WEB CUTTING DIAGRAM FOR G1A THRU G5A

DESCRIPTION:	CAMBER AND FLANGE DIAGRAMS	DRAWN BY:	DATE
JOB:	US Route 5 over Northern Vermont RR	WL	08/01
	BRIDGE NO. 161	CHKD BY:	
	BARTON, VERMONT (ORLEANS COUNTY)	JAK	08/05
	CONTRACTOR: WINTERSET	APPROV BY:	
		SUPERVISOR:	H. J. GATTI
PROJ NO.	AC STP 0113 (58) S	Q.A.	
CUSTOMER:	VERMONT AGENCY OF TRANSPORTATION		
<b>CASCO BAY STEEL STRUCTURES, INC.</b>		JOB NO.	DRG. NO.
75 SPRING HILL ROAD	SACO, MAINE 04072	163	C1
PHONE (207) 282-7360	FAX. (207) 282-1179	REV.	△

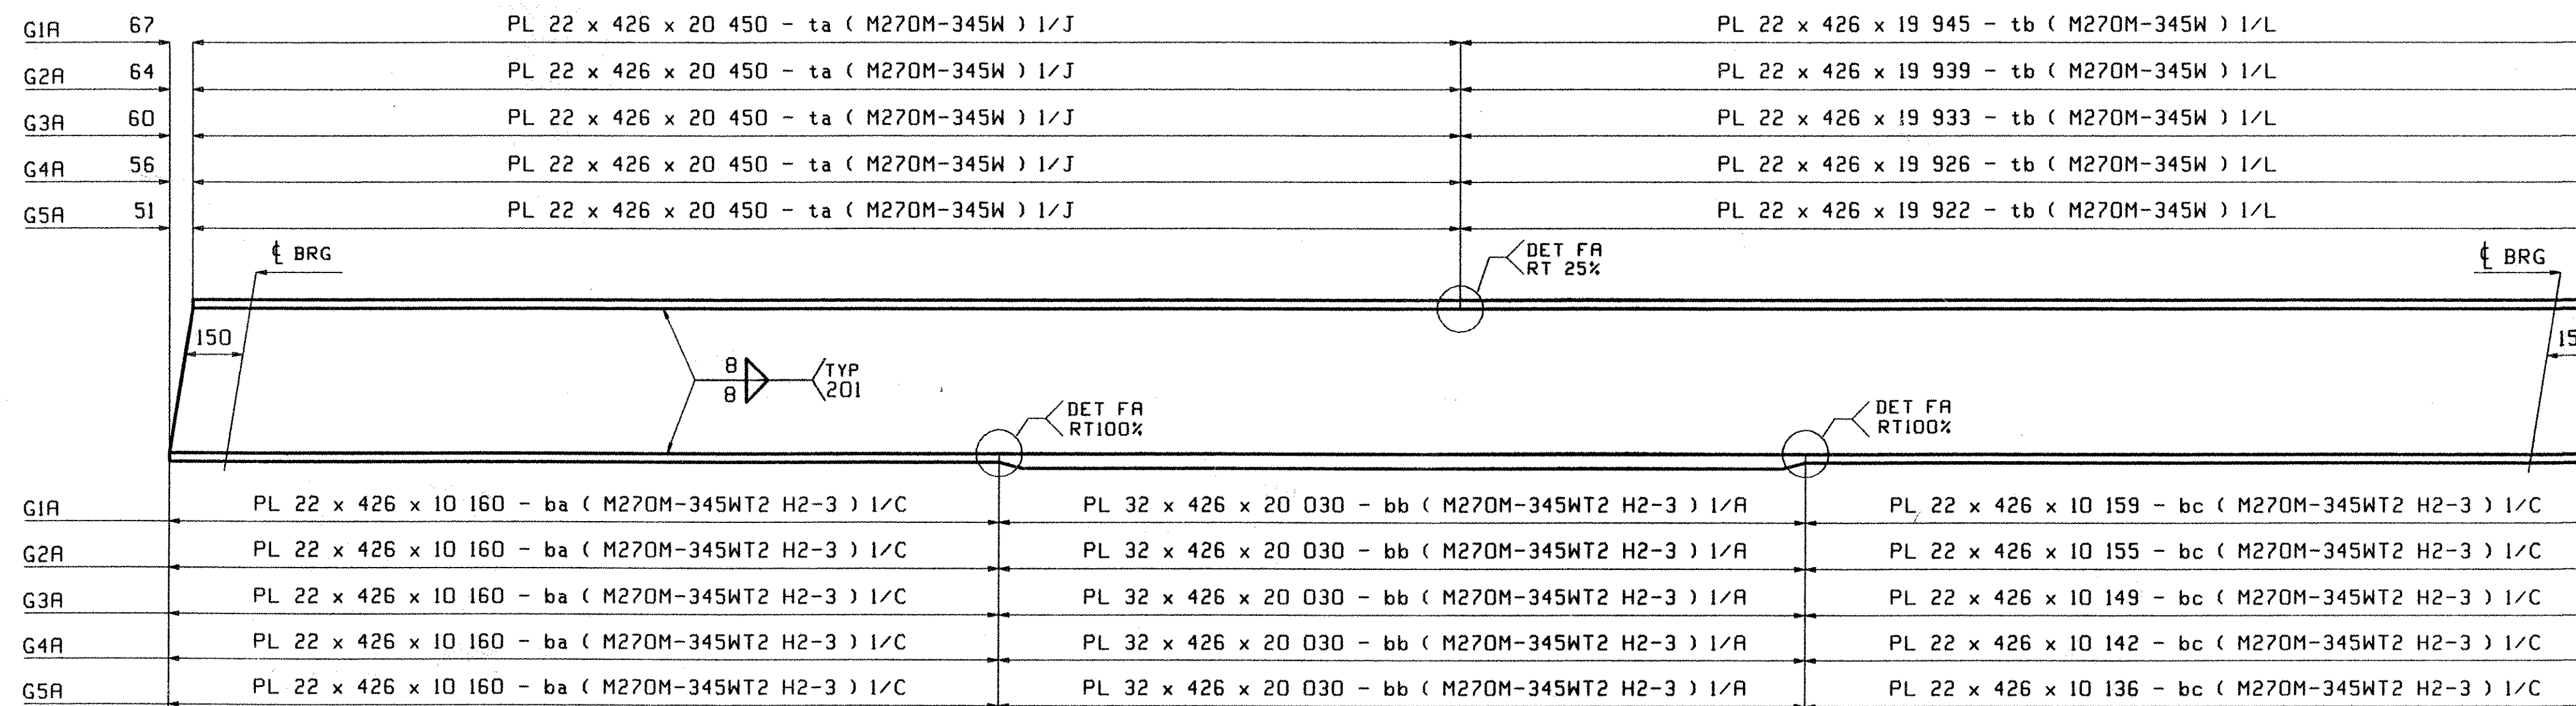
RECEIVED  
 OK'D BY: *WJ* OK'D BY: *R34*  
 SEP 04 2002  
 RESUBMIT: \_\_\_\_\_ APPROVED: *Ab*  
 BY: *CPW* DATE: *9/17/02*
